CERTIFICATE OF APPROPRIATENESS

Property: 1409 Ashland Street, Lot 16, Tract 17A, Block 151, Houston Heights Subdivision. The property includes a historic 1,114 square foot, one-story wood frame single-family residence and a detached secondary structure situated on a 6,600 square foot (50' x 132') interior lot.

Proposal: Alteration – Addition *Resubmittal*

NORTH SIDE ELEVATION

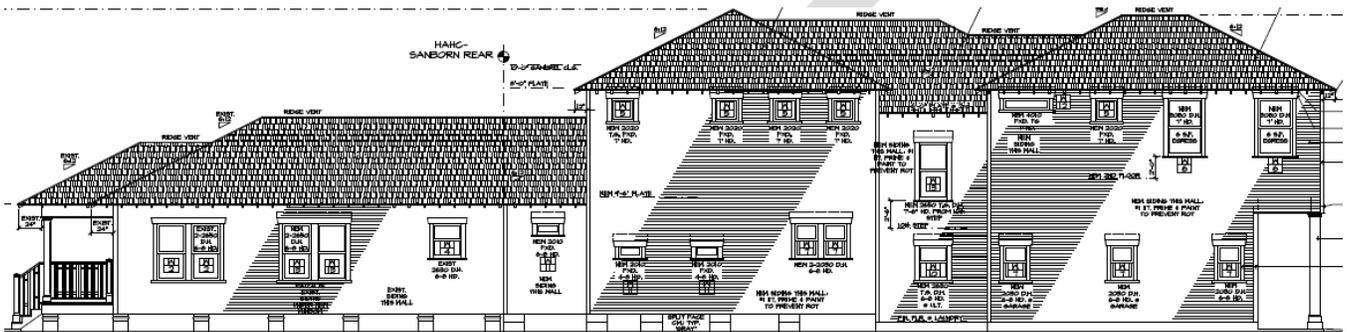
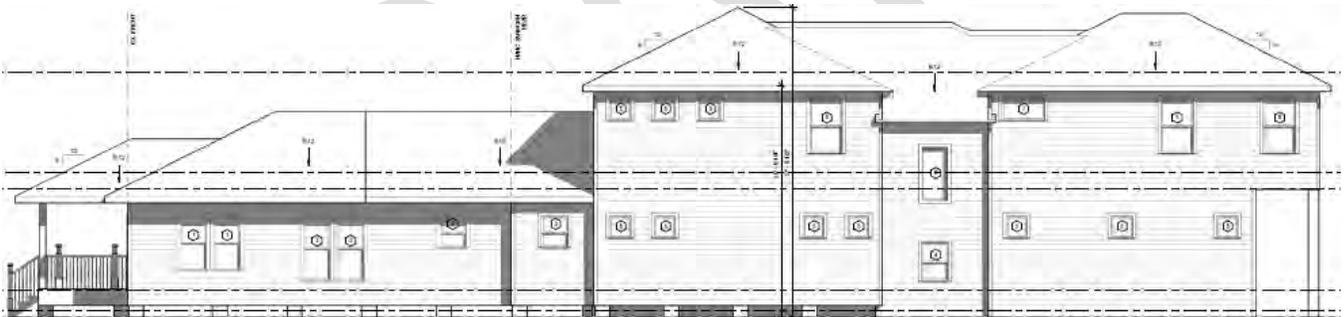
- Remove a proposed south facing chimney bump out on the proposed addition.
- Extend the approved south facing side porch to extend over the previously proposed bump out.
- Adjust the fenestration pattern on the front and side elevations of the proposed addition.

Side Elevation: The residence features a pair of wood windows to be retained, a pair of aluminum windows to be removed and replaced with wood windows and a single wood window to be retained. An existing rear shed addition will be removed and the addition will begin at the original rear wall and feature nine windows on the first floor and nine windows on the second floor. See elevation drawings for details.
(North)

SOUTH SIDE ELEVATION

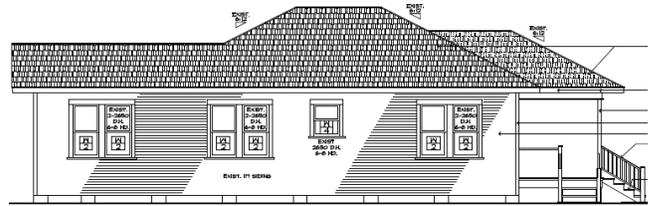
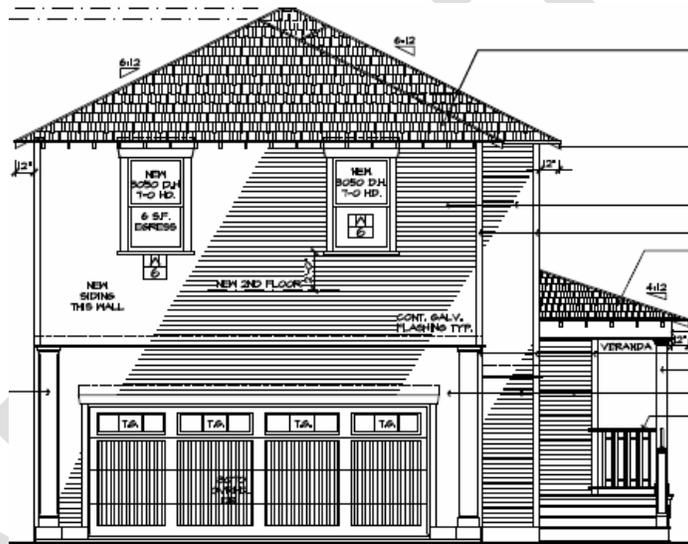
Proposed: An approved south facing chimney bump out on the rear addition will be removed. The approved south facing side porch will be extended over this area.

Side Elevation: The residence features, from east to west, a pair of wood windows to be retained, an aluminum window to be removed and replaced with a wood window, a pair of wood windows to be retained and a pair of wood windows on an existing addition to be removed. The addition will retain a portion of the existing addition's wall and start 7'-10" behind the original rear wall, inseting 1' for 3'-4" before popping back put 2'-6" to a 7'-4" wide direct vent chimney on the first floor. The addition will then extend back 23'-10", step back and extend a final 29'-1" including a 5'-9" portico covered by conditioned space on the second floor. The second floor will feature seven windows. The first floor will feature two windows and a door at the rear garage portion. A side porch measuring 21'-9" wide by 6'-10" deep will begin after the direct vent chimney. The wall behind it will feature two pairs of doors and a window. See elevation drawings for details.
